TSB - JD01

Models applicable > John Deere 2130 to 3130

CLUTCH UPGRADE USING 320mm REPLACEMENT

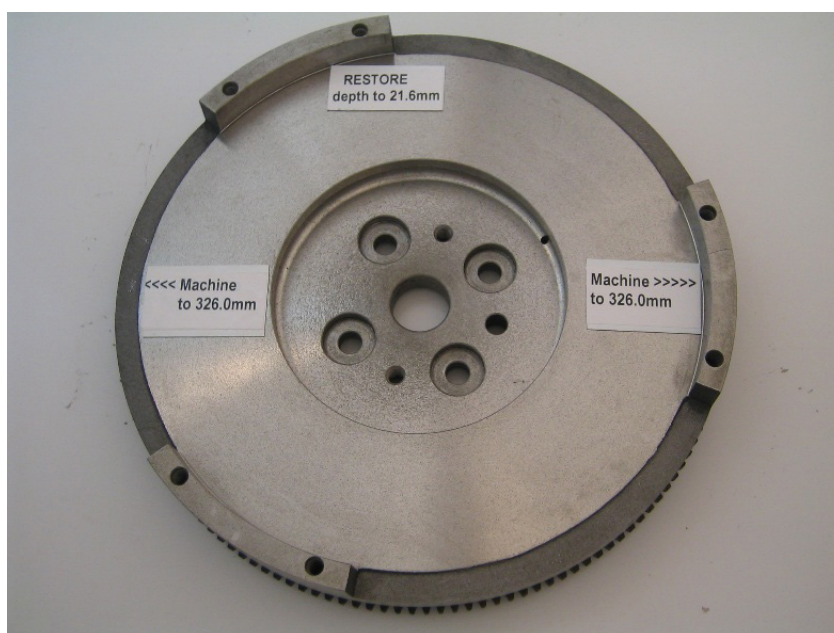
As shown above, the cover mounting surface of the flywheel must be increased to accommodate the larger clutch.

The original diameter = 308.0mm must be machined out to the new diameter of 326.0mm

The flywheel depth must also be restored to 21.6mm (.850 > in) as per the original specification.

The cover locating studs must be re-fitted using Loctite or a similar retaining compound.

The replacement diaphragm assembly requires a longer bolt set:
